ADDENDUM

NO. 3

PROJECT NAME: Lehman High School 2025 Additions and Renovations

ADDENDUM DATE: 14 May, 2025

PACKAGE	VOLUME
Job No. 01954-08-01	Sheet No. ISSUE FOR BID
Drawn By: RAU	C2.02
Date: 05/15/2025

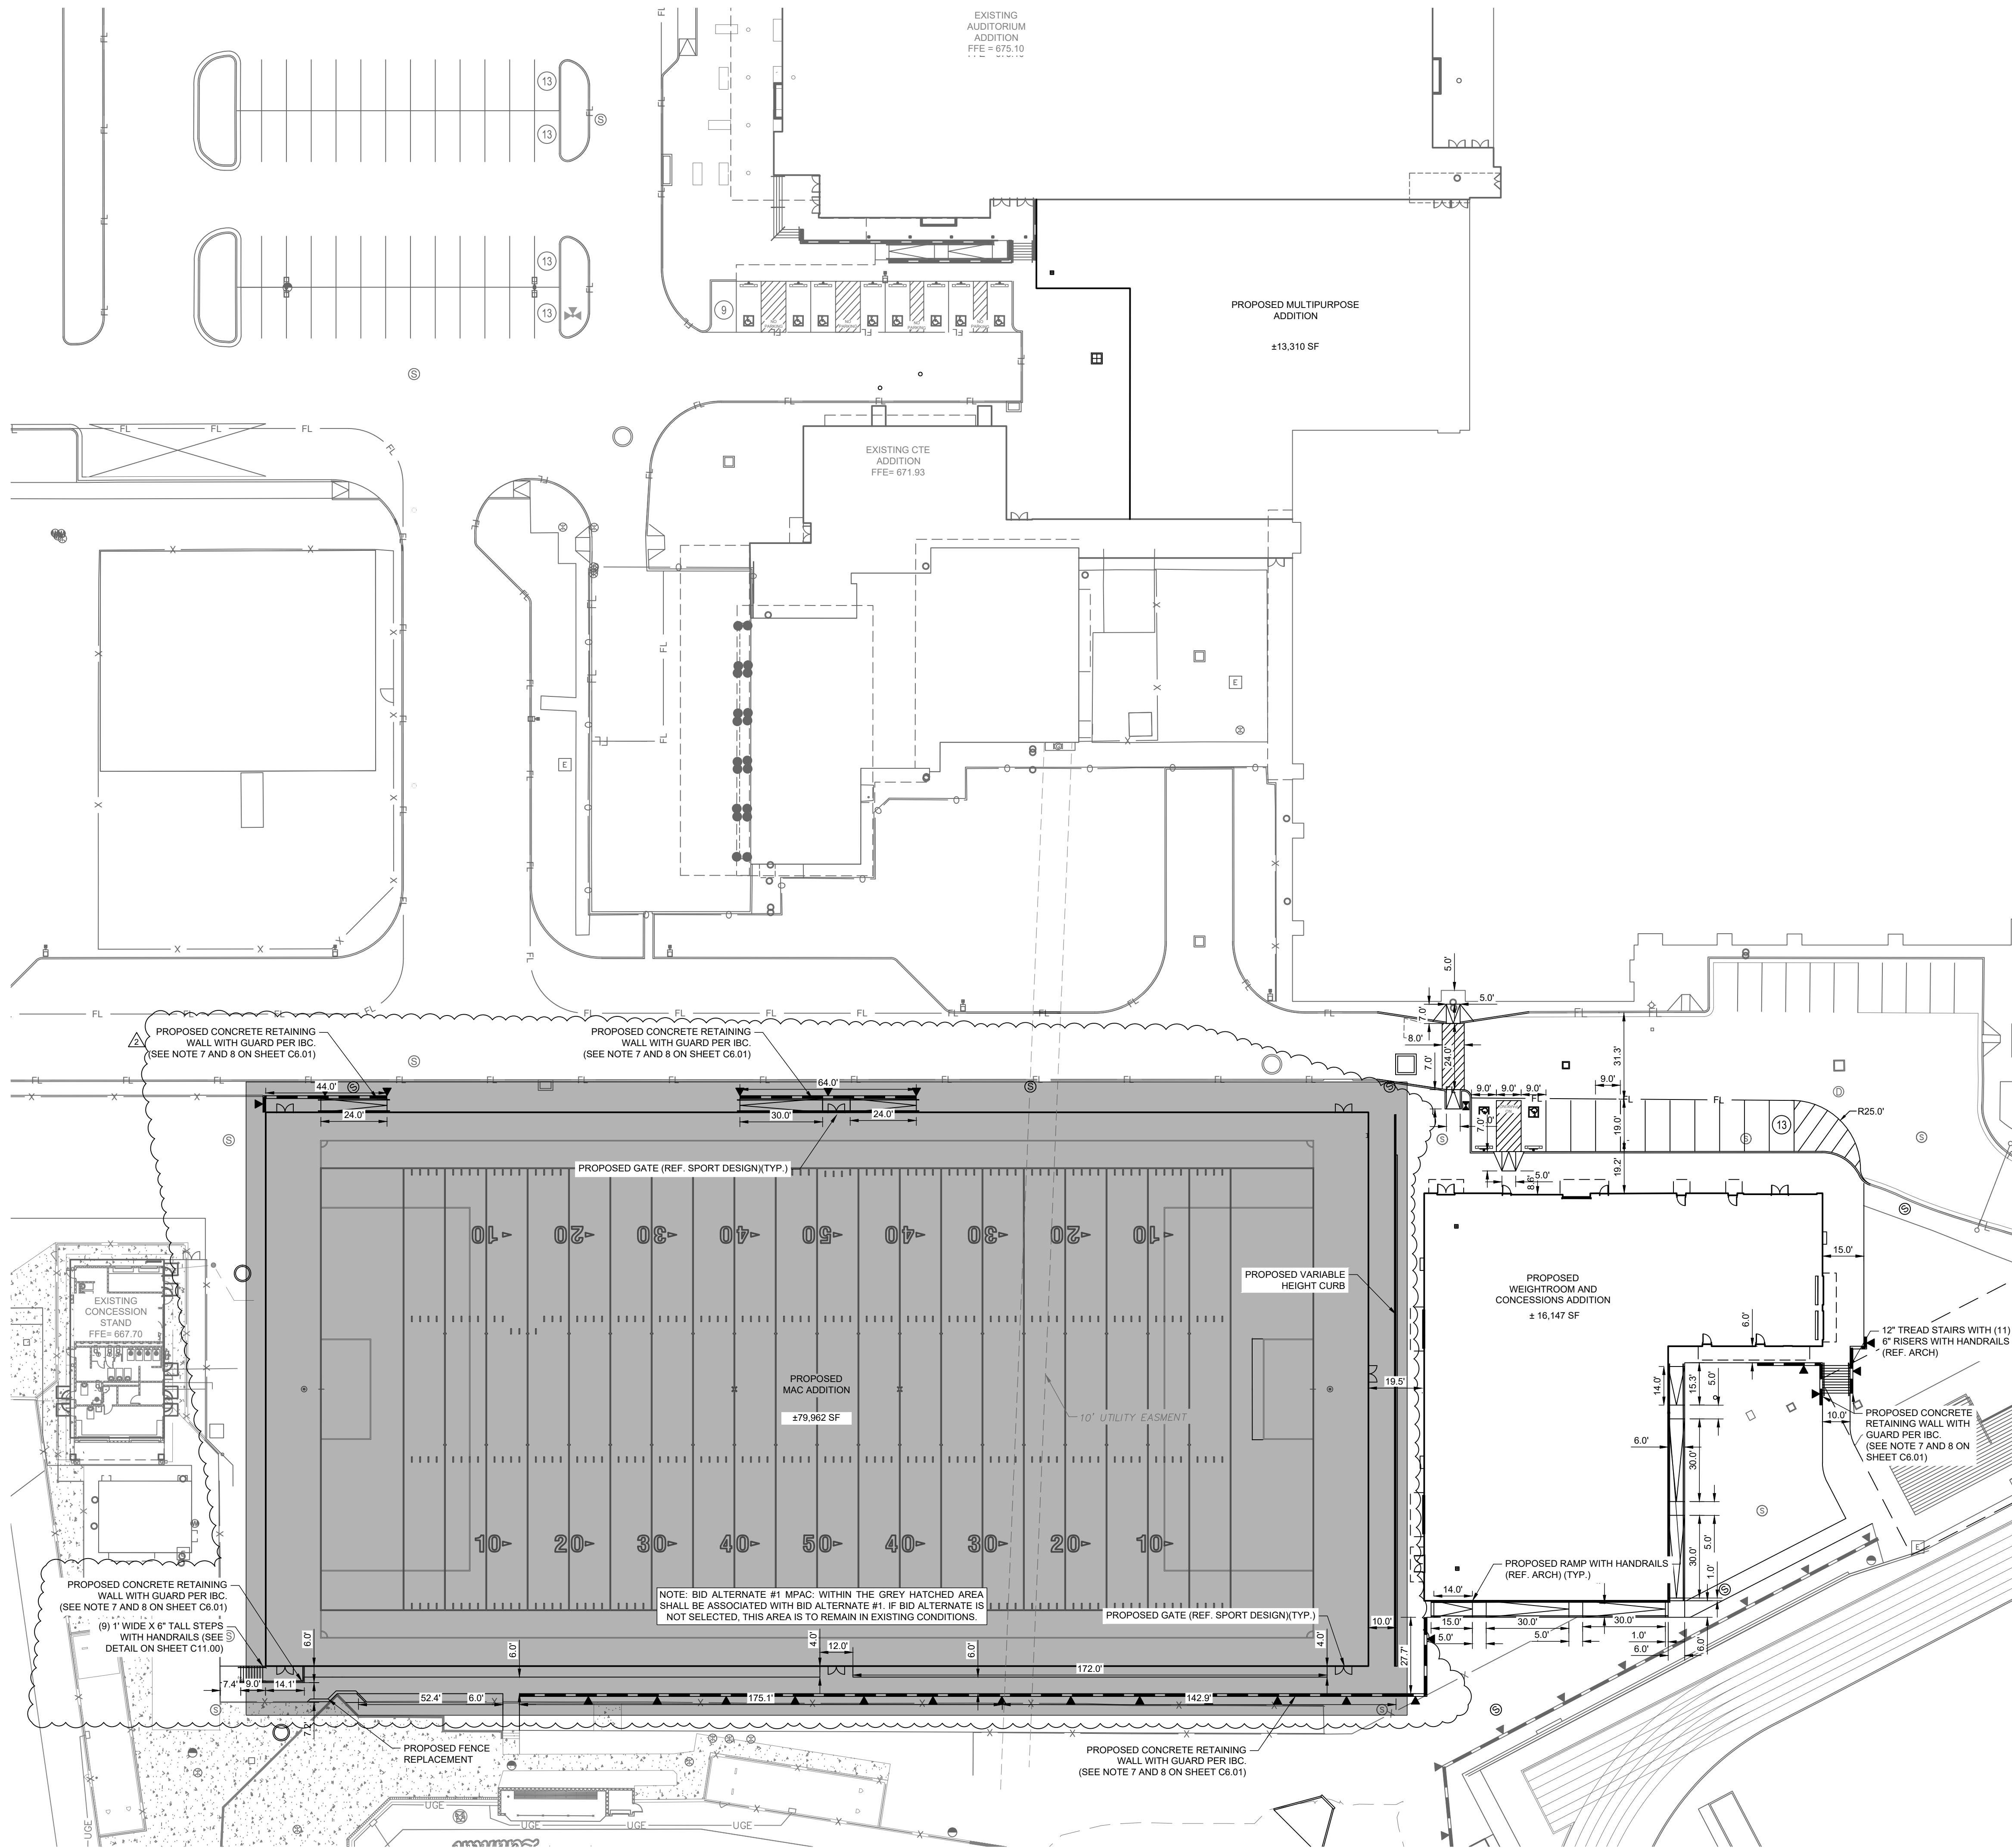
- 1) Reroute of sanitary sewer line.

DIMENSION CONTROL PLAN (1 OF 2)	
PACKAGE	VOLUME
Job No. 01954-08-01	Sheet No. ISSUE FOR BID
Drawn By: RAU	C4.01
Date: 05/15/2025

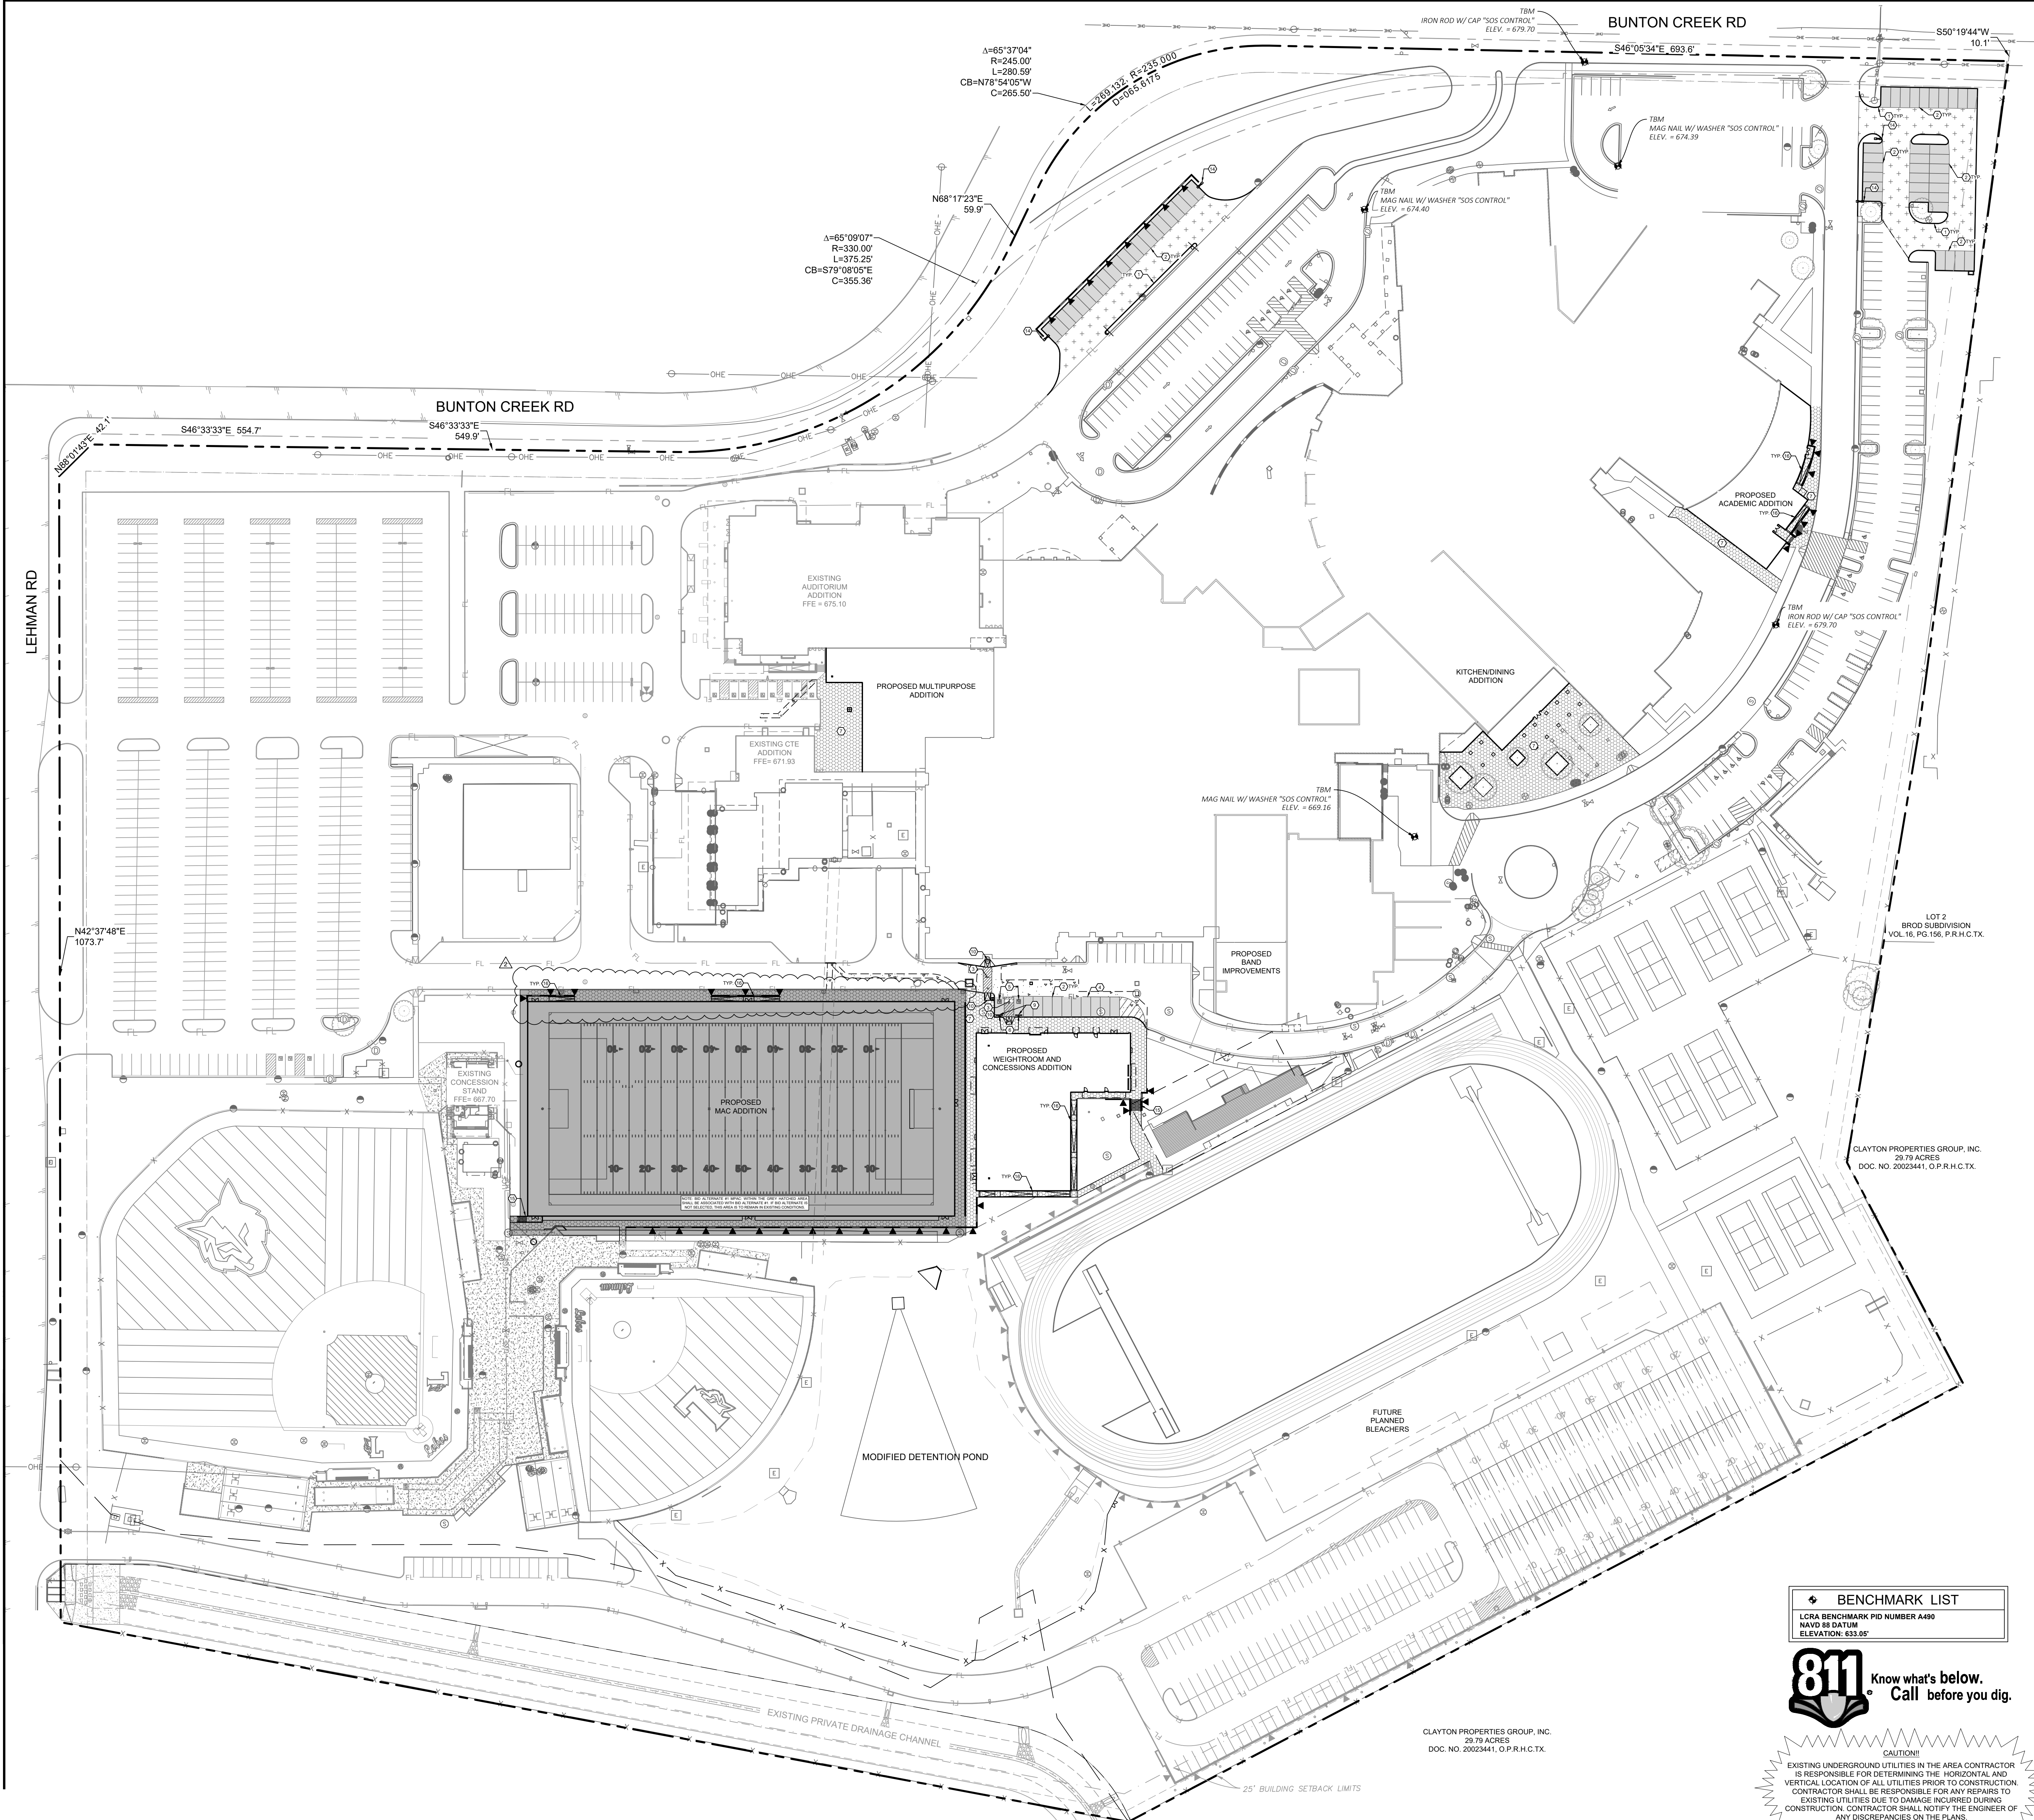
- 1) Adjustment of MAC footprint and ramps.

PACKAGE	VOLUME
Job No. 01954-08-01	Sheet No. ISSUE FOR BID
Drawn By: RAU	C5.01
Date: 05/15/2025

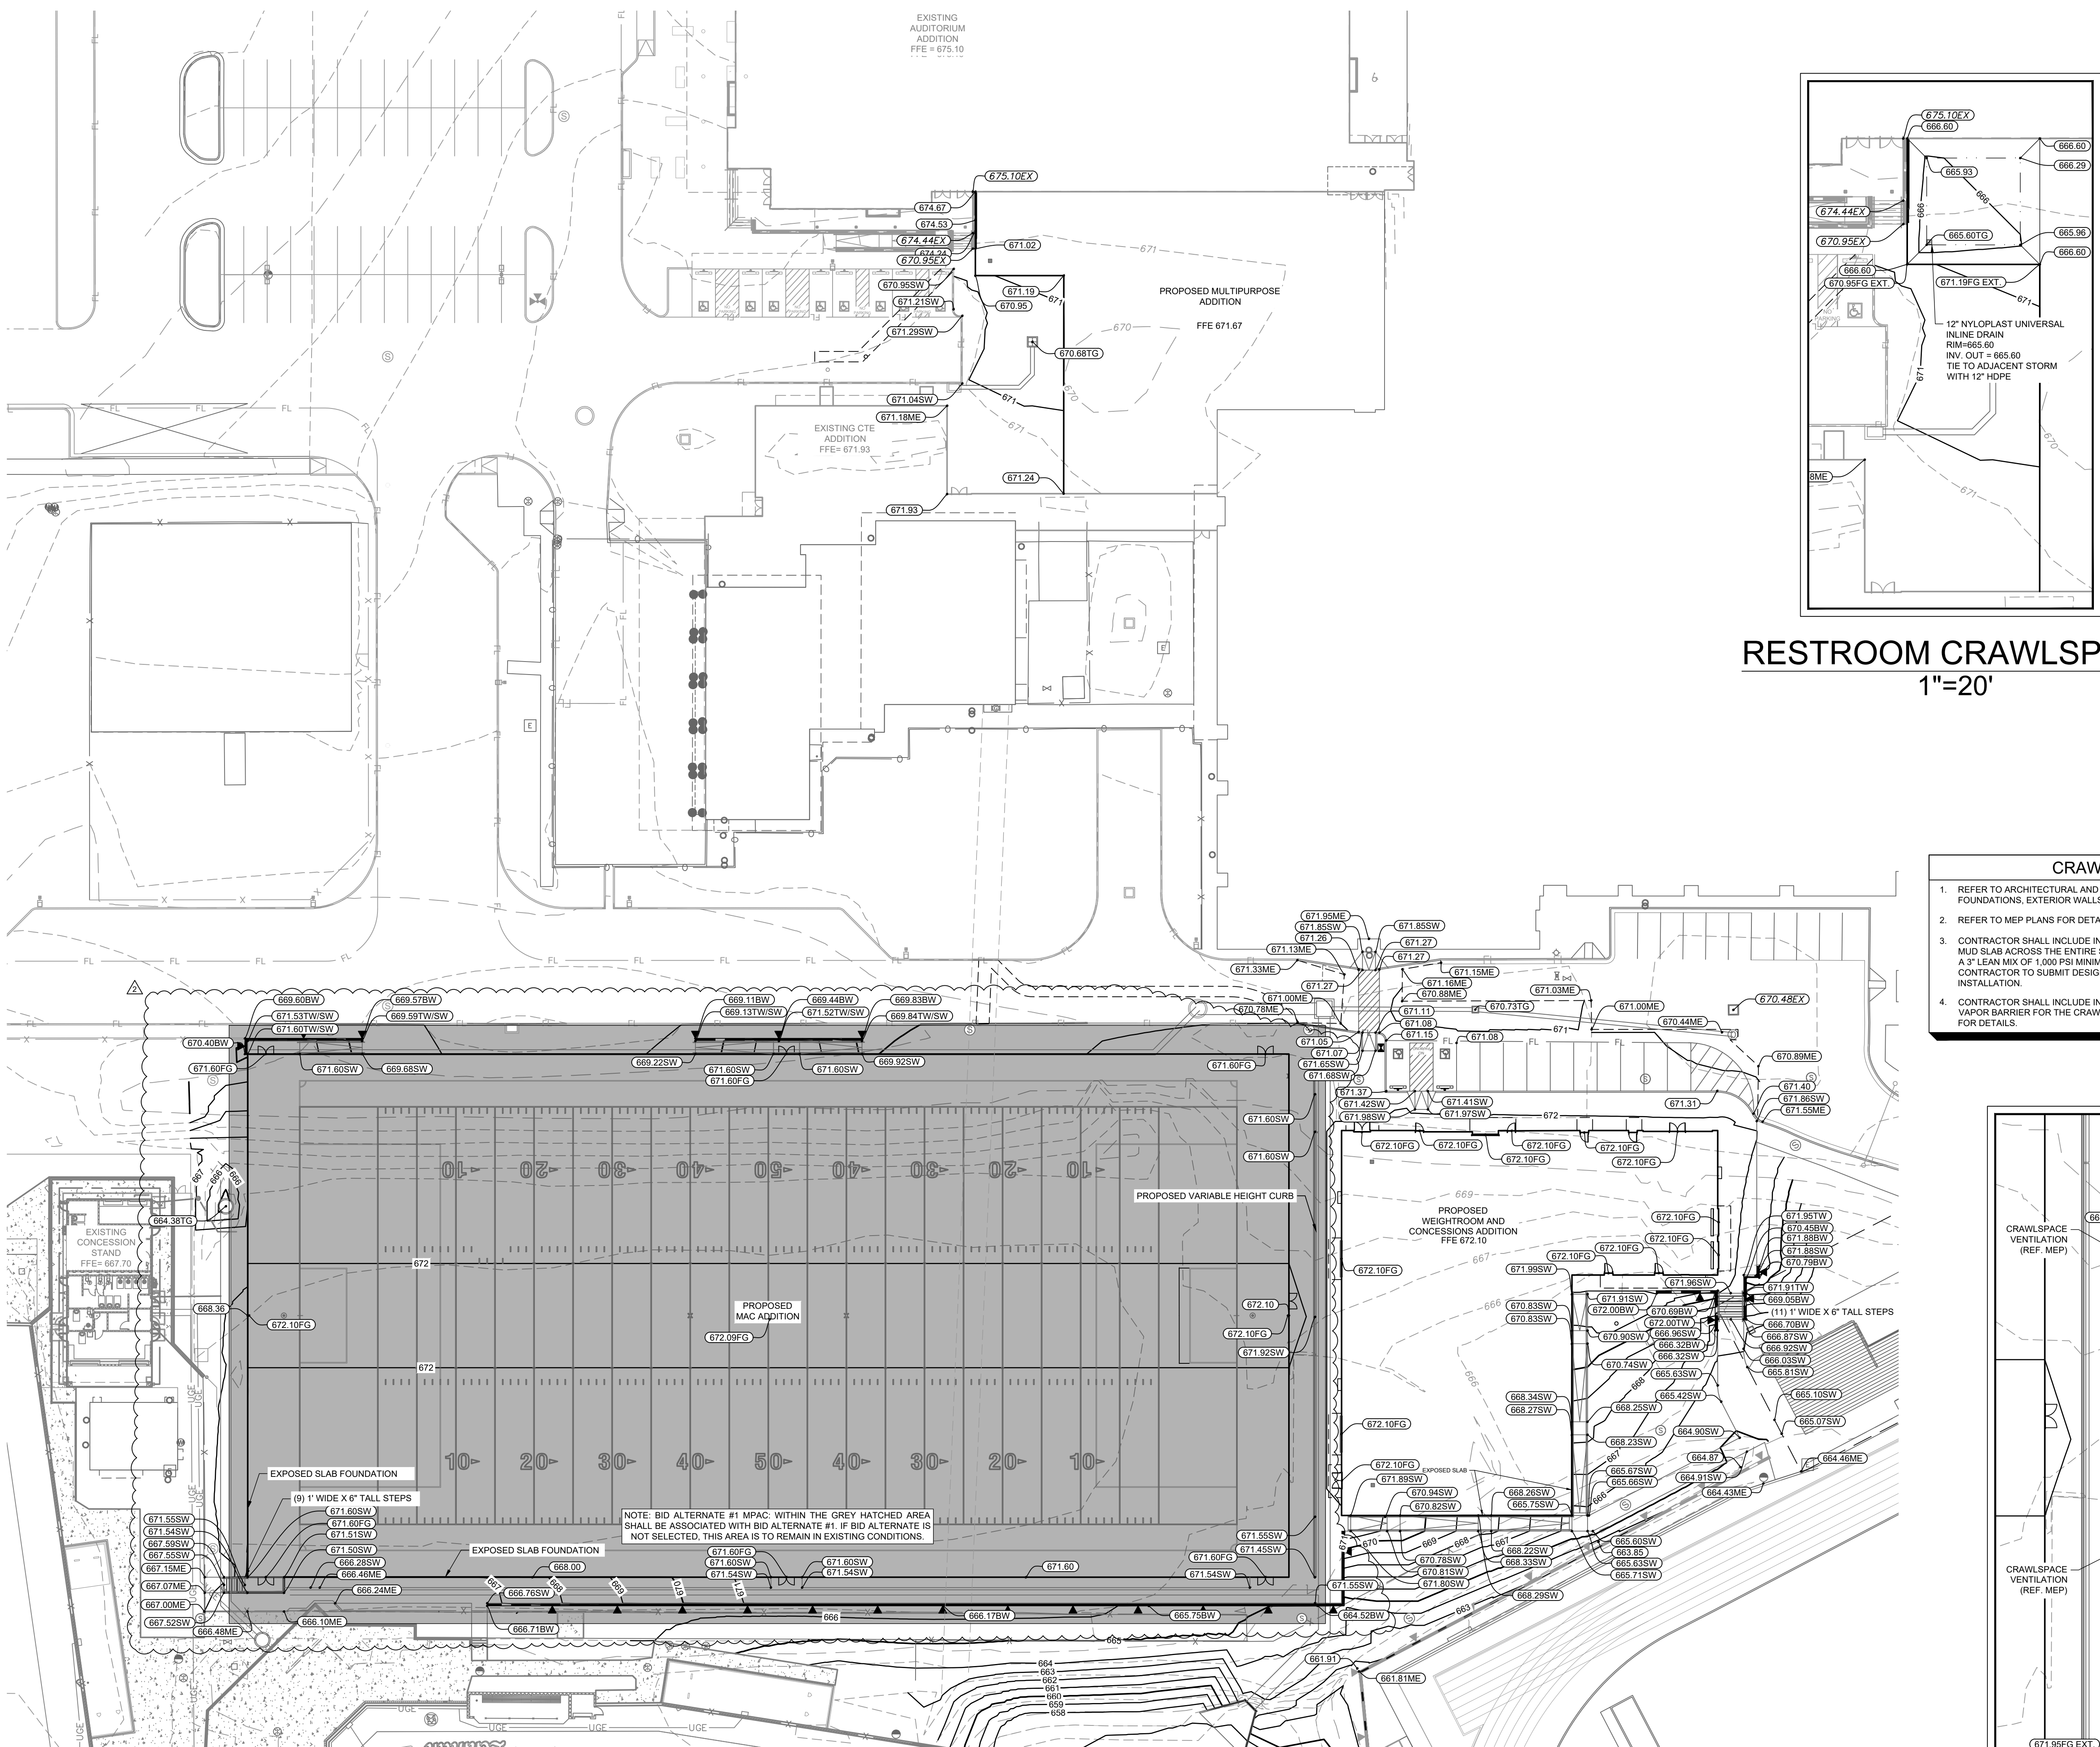
- 1) Adjustment of MAC footprint and ramps.
